EDINBURG PLANNING AND ZONING COMMISSION
CITY OF EDINBURG, HIDALGO COUNTY, TEXAS

JULY 23, 2026
5:30 PM

**MINUTES
PLANNING AND ZONING COMMISSION
CITY OF EDINBURG, HIDALGO COUNTY, TEXAS**

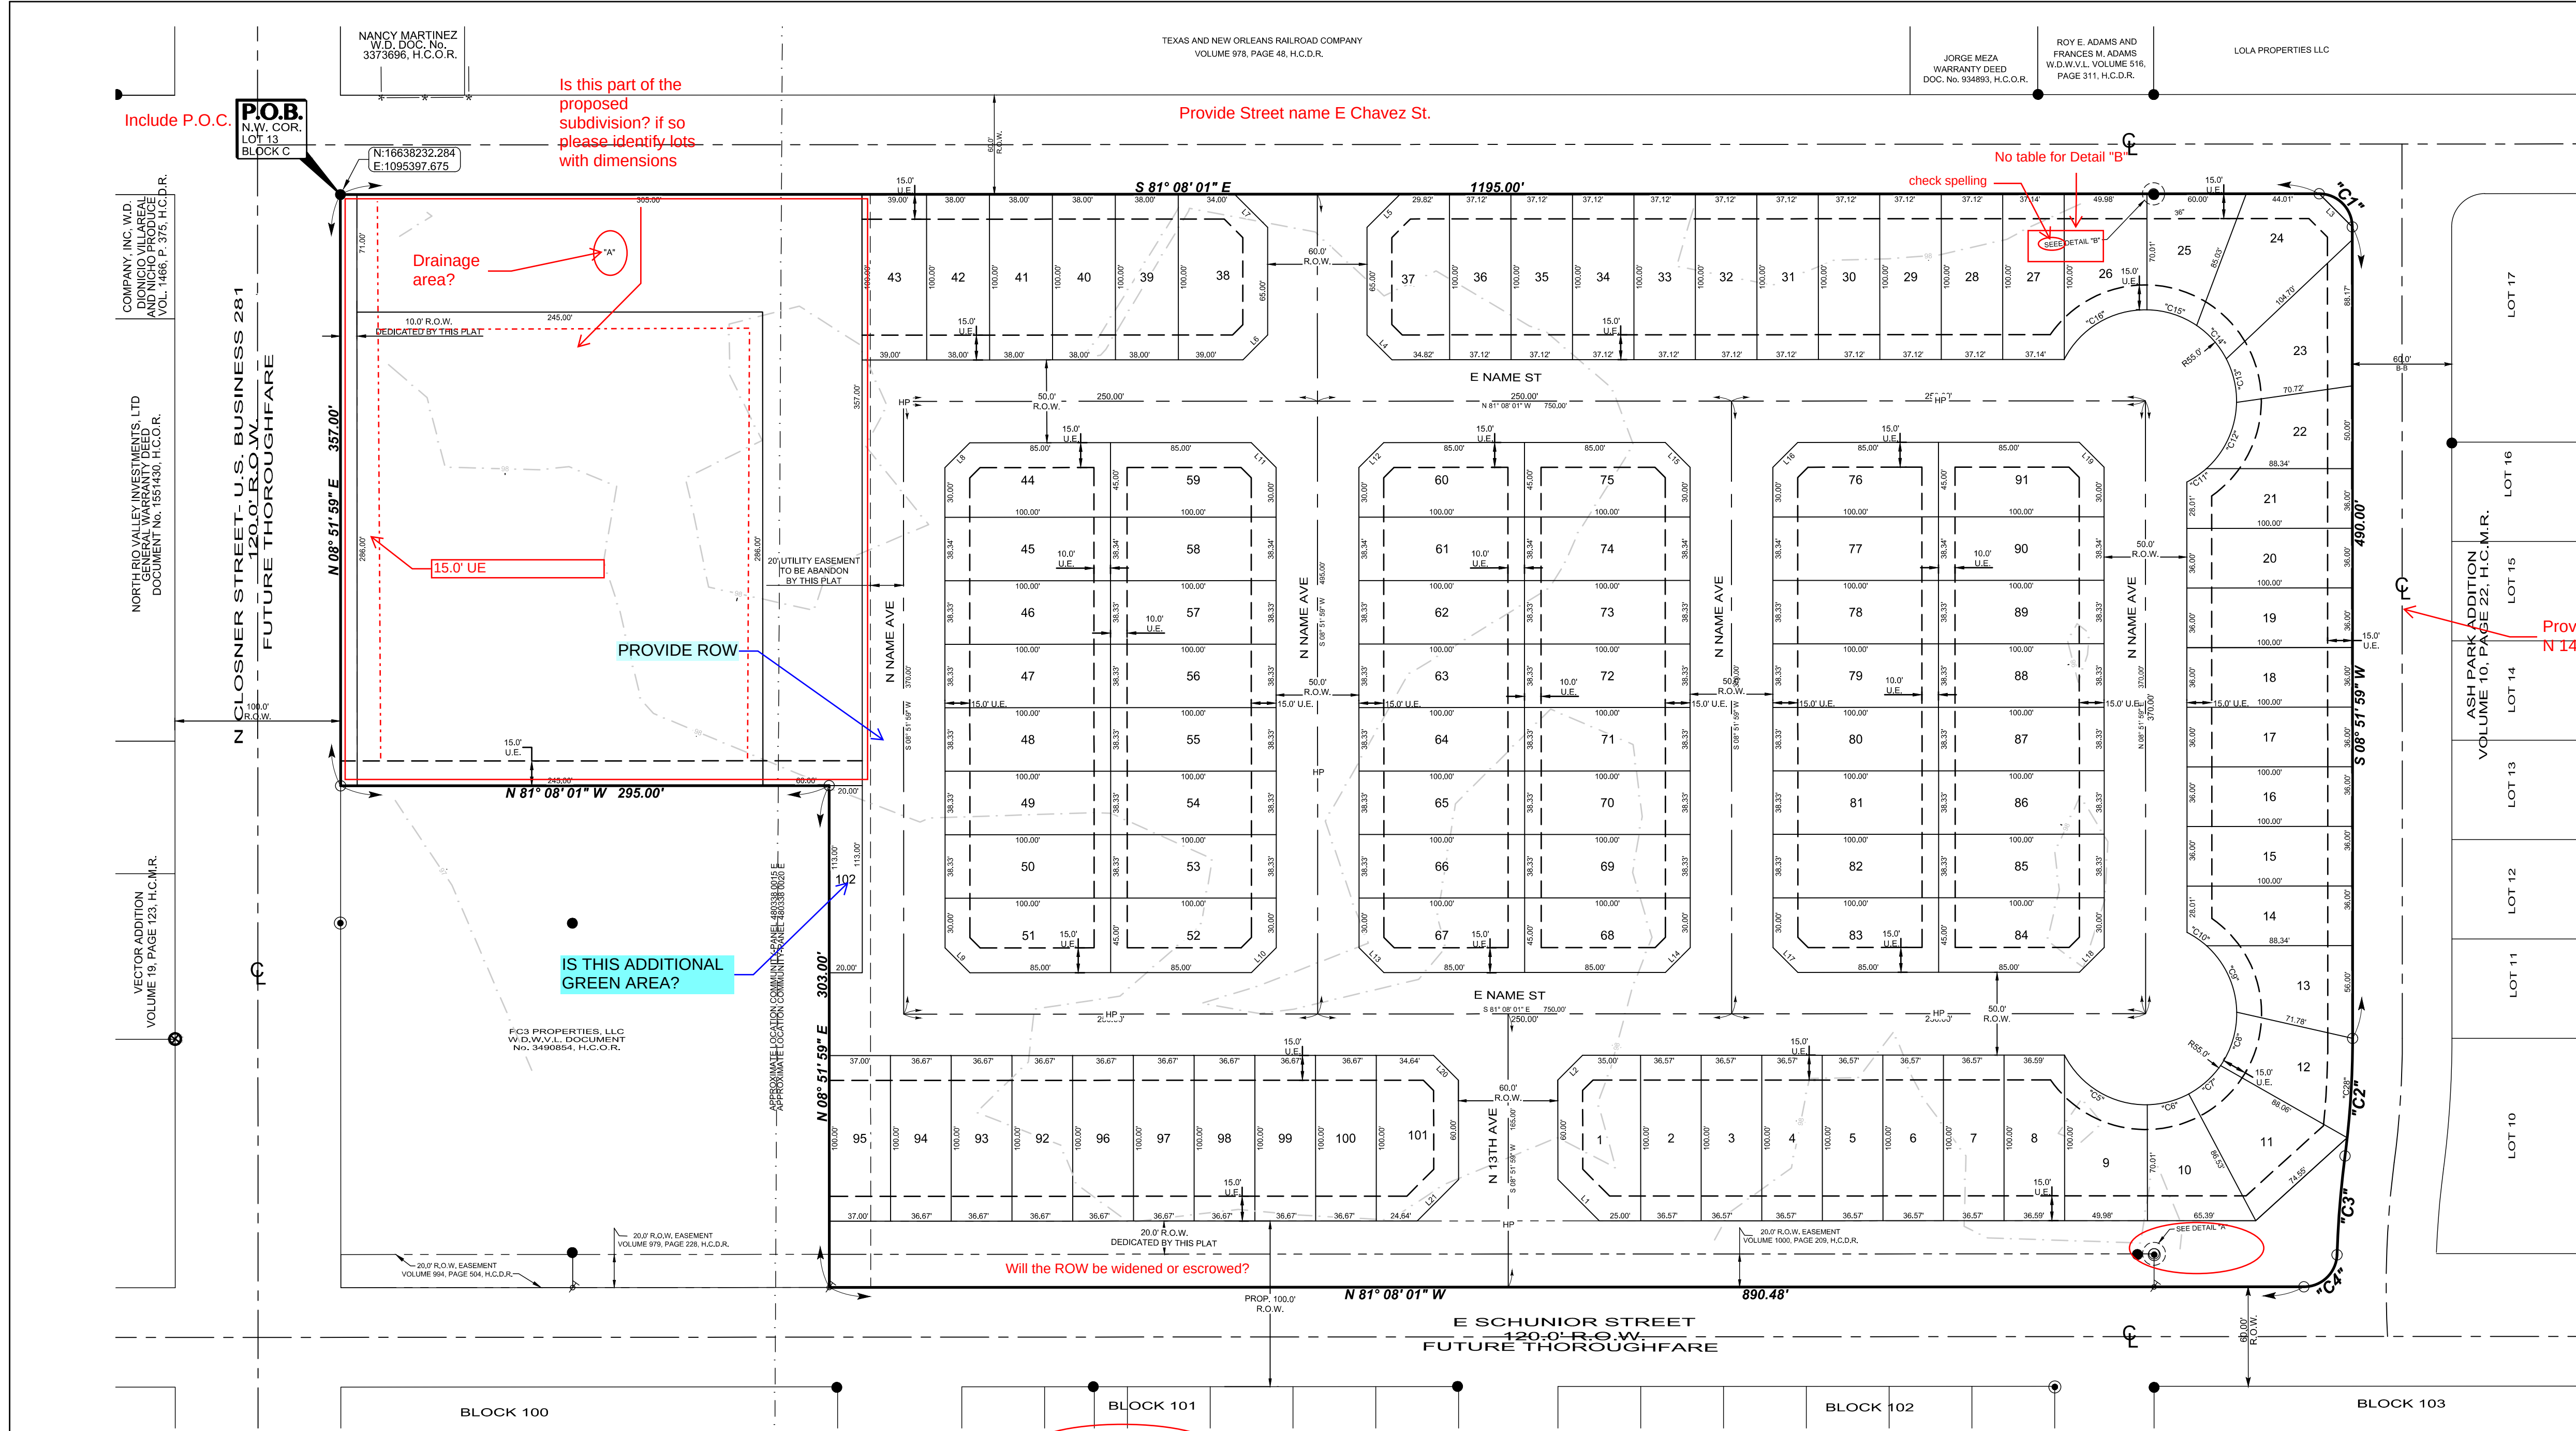
Verify street names with GIS team.

Provide Street name N 14th PL

clarify what lot 102 is on the plat?
